INDIANA & MICHIGAN POWER COMPANY
DONALD C. COOK NUCLEAR PLANT

PLANT MANAGER PROCEDURE

Instruction or Procedure Temporary Sheet

<p>This temporary sheet applies to Emergency Plan Activation & Cond. Classification</p> <p style="text-align: center;">Instruction or Procedure No. PMP 2080 EPP .001 Revision No. 1 Exhibit A</p>	<p>TEMPORARY SHEET NO.</p> <p>2</p>
<p>The following change (<input checked="" type="checkbox"/>) new requirement () shall be instituted effective (Date) <u>March 15, 1982</u></p> <p style="margin-left: 40px;">Change ECC-13, item 2g to read:</p> <p style="margin-left: 80px;">Unit vent gas monitor (R-26) exceeds:</p> <p style="margin-left: 120px;">1×10^4 cpm (fresh gas) or 1×10^3 cpm (old gas)</p> <p style="margin-left: 40px;">Use the "old gas" criterion for:</p> <p style="margin-left: 80px;">A. Release originating from a gas decay tank, shown by unexplained GDT pressure decrease seen on recorders MR 058 or MR 059.</p> <p style="margin-left: 80px;">B. Release originating from a CVCS hold-up tank, shown by unexplained CVCS hold-up tank header pressure decrease (QPA 600) and possibly excessive cover gas demand.</p> <p style="margin-left: 40px;">Use the "fresh gas" c

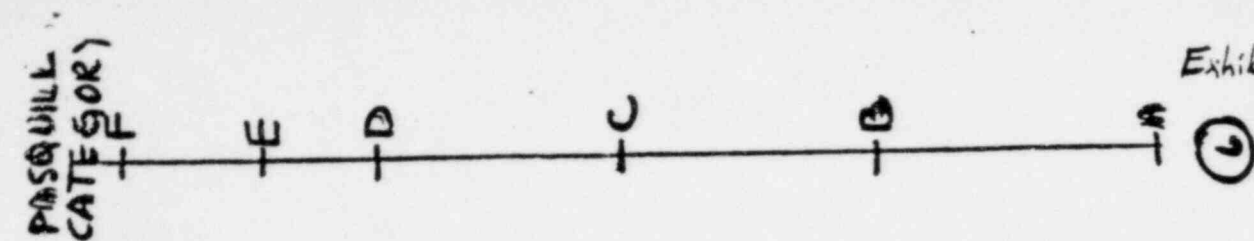
<p>This temporary sheet applies to <u>Emergency Plan Activation + Condition Classification</u> Instruction or Procedure No. <u>PMP 2080 EPP .001 Exhibit A</u> Revision No. <u>1</u></p>	<p>TEMPORARY SHEET NO. <u>3</u></p>
<p>The following change (X) new requirement () shall be instituted effective (Date) <u>March 15 1982</u>.</p> <p style="margin-left: 40px;"><u>ECC-19: Radiation Release</u> Under "Unusual Event" add: See also ECC-13 for classifications of specific RMS monitor readings.</p> <p style="margin-left: 40px;">Under "Alert" add: See also ECC-13 for classifications of specific RMS monitor readings.</p> <div style="border: 1px solid black; width: 200px; height: 100px; margin: 20px auto;"></div> <p style="text-align: right; font-size: 1.5em; margin-top: 20px;">OR</p> <p style="margin-top: 20px;">Reason: To ensure that ECC-13 criteria are considered as well as ECC-19 criteria under rad. release conditions</p>

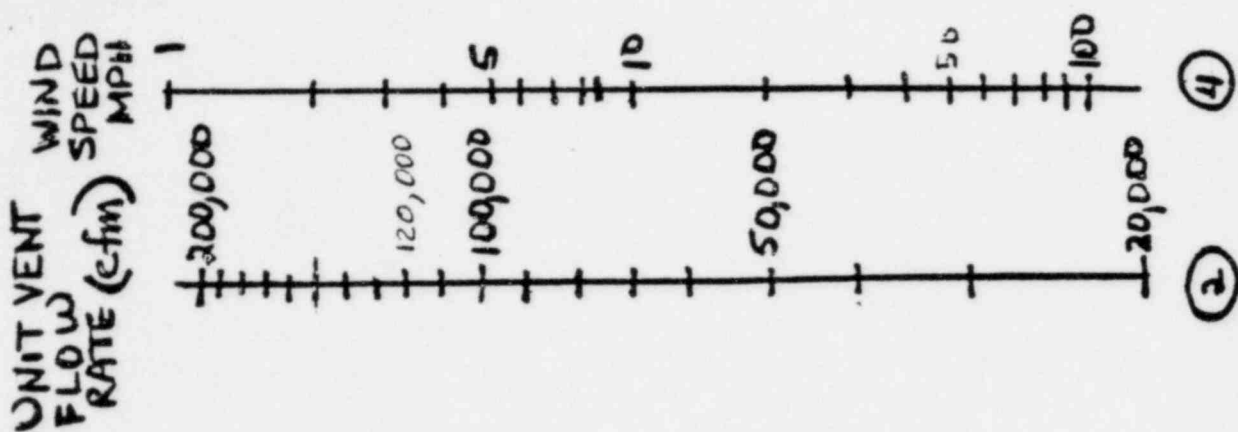
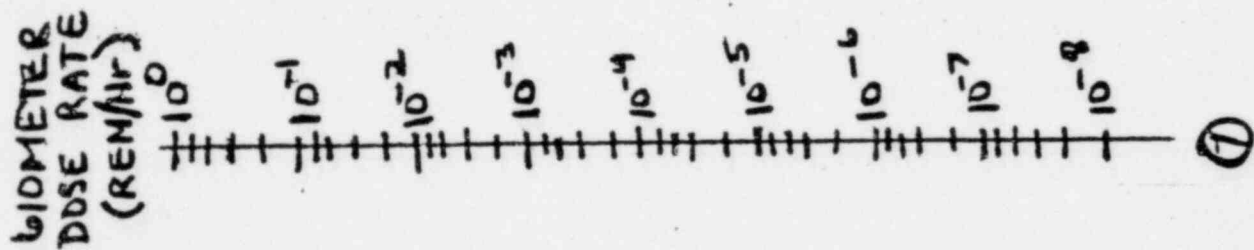
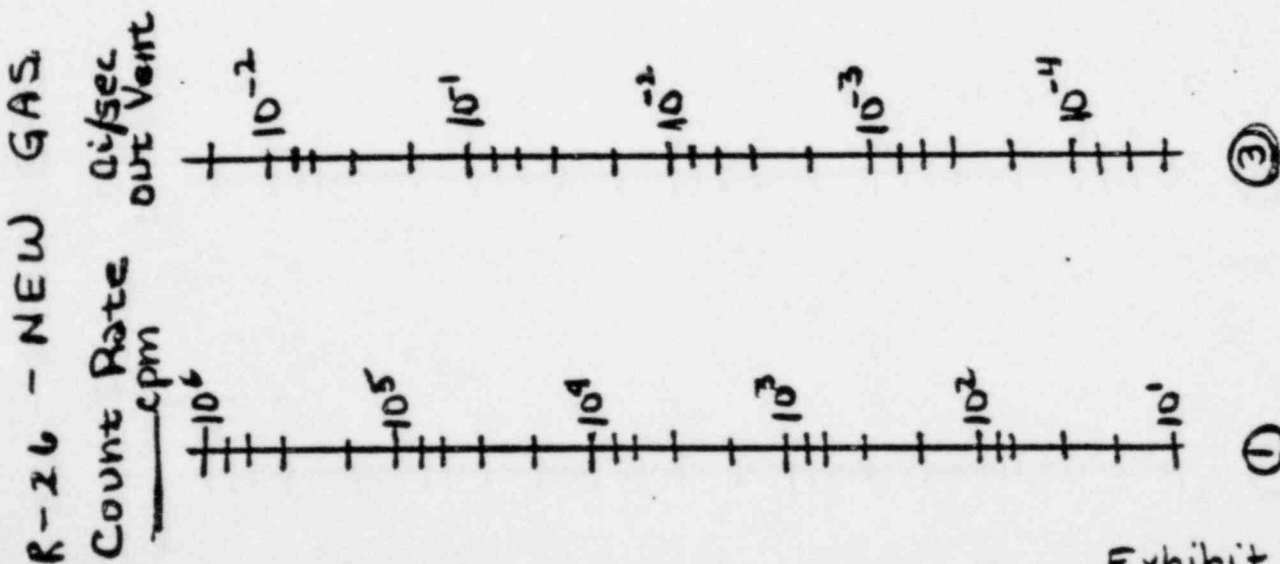
<p>This temporary sheet applies to Initial Dose Assessments (Gaseous) Instruction or Procedure No. PMP 2080.EPP.006 Revision No. 1</p>	<p>TEMPORARY SHEET NO.</p> <p>1</p>
<p>The following change (X) new requirement () shall be instituted effective (Date) <u>3-12-82</u>.</p> <p>Make the following Pen & Ink Changes</p> <p>List of Effective Pages - Add Page 3A TP-1 Exhibit A</p> <p>Pg. 2 of 11 - Sec. 4.5 - change Site Boundary Dose Rate for Site Emergency From ≥ 25 mR/hr to ≥ 50 mR/hr.</p> <p>Pg. 3 of 11 - Draw diagonal line thru page and place note on page stating "Revised see Page 3A TP-1.</p> <p>Insert attached page 3A TP-1 after page 2 of procedure.</p> <p>Reasons: Corrects error in dose rate for site emergency and provides more realistic dose from R-26.</p> <div style="text-align: right; margin-top: 100px; font-size: 2em; font-weight: bold;">OR</div>	
<p>This change should be made a permanent revision to the Instruction or Procedure:</p> <p><input checked="" type="checkbox"/> YES <input type="checkbox"/> NO <input type="checkbox"/> NOT KNOWN, additional review required</p>
